Public Service
Company of Colorado

March 22, 1988
Fort St. Vrain
Unit No. 1
P-88062

SUBJECT: Final Draft Upgrade
Electrical Technical
Specifications
Sections 3/4.8

UPGRADED TECHNICAL SPECIFICATIONS
FOR AUXILIARY ELECTRIC POWER SYSTEMS

FIG. 3.8.1-1

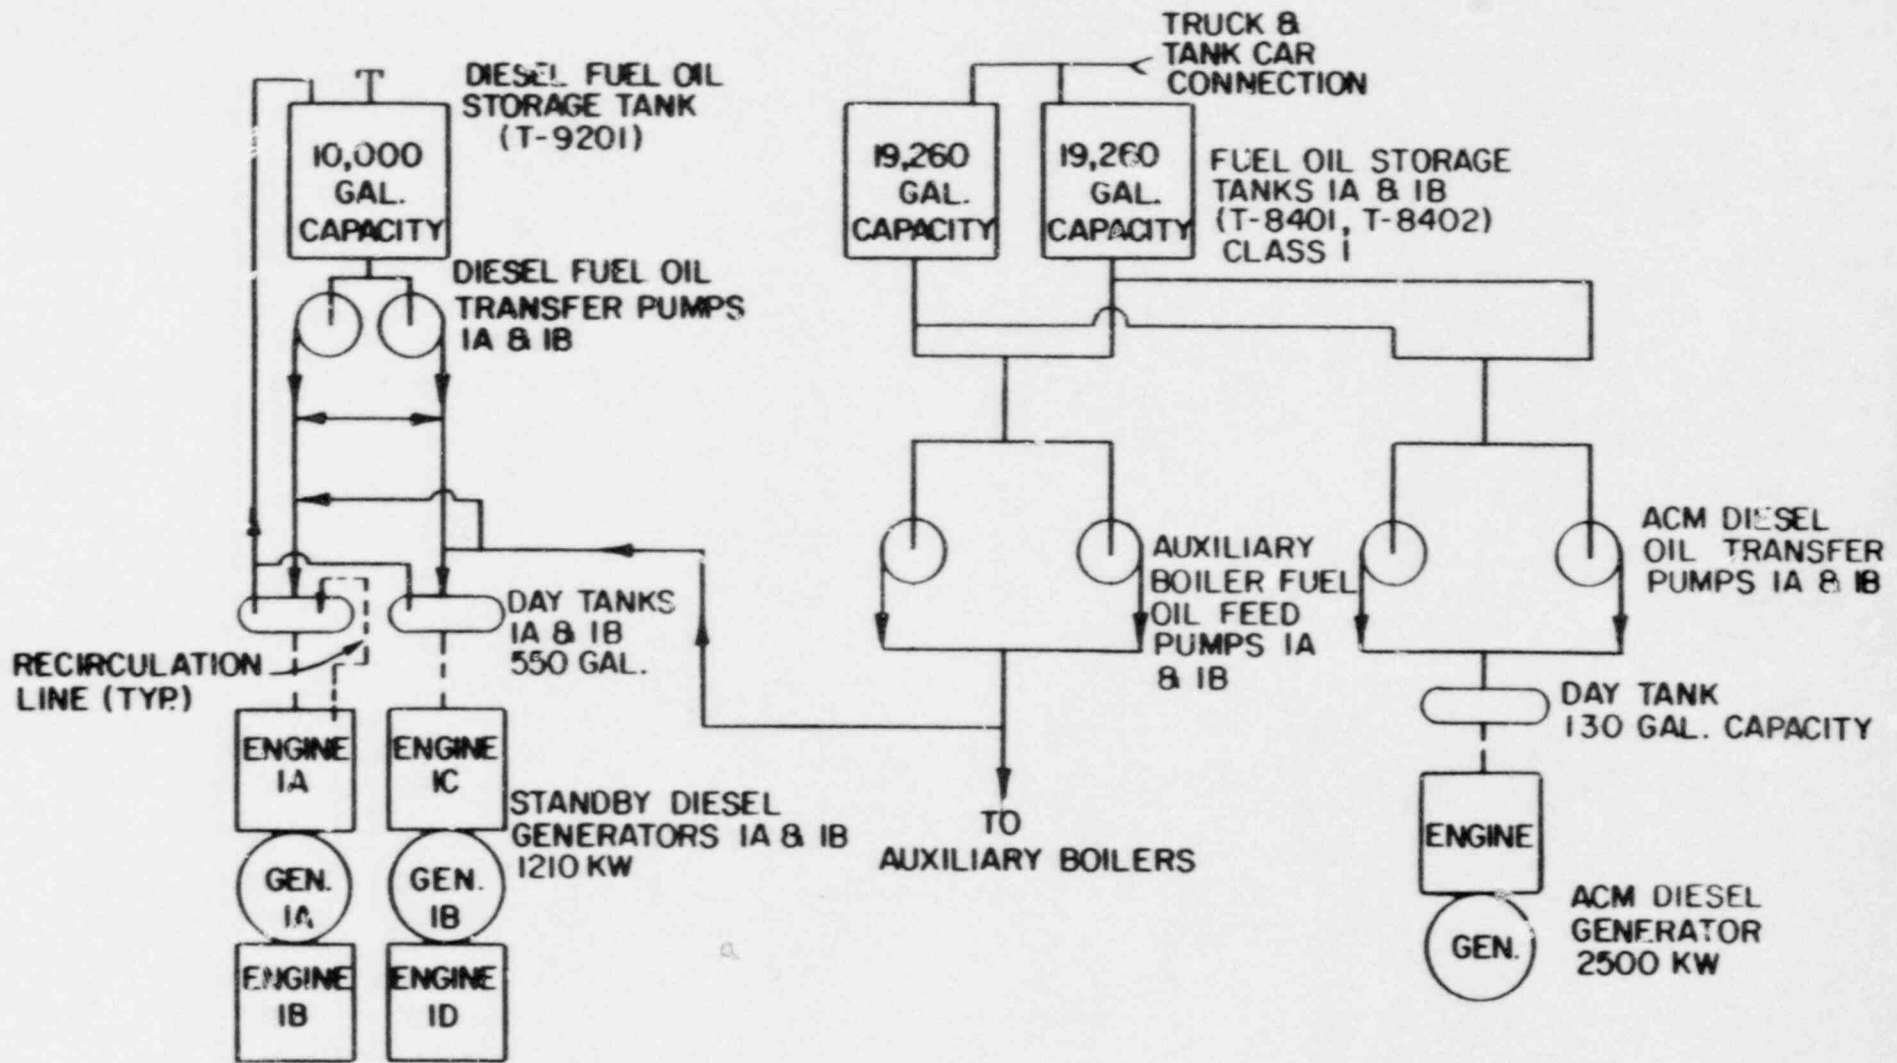
3.8.1.2.b.4	Decreased the minimum required quantity of lubricating oil consistent with the reduction in quantity of diesel fuel oil required in 3.8.1.2.b.2.
Figure 3.8.1-1	Revised ACM Day Tank capacity to 130 gallons consistent with as-built design.
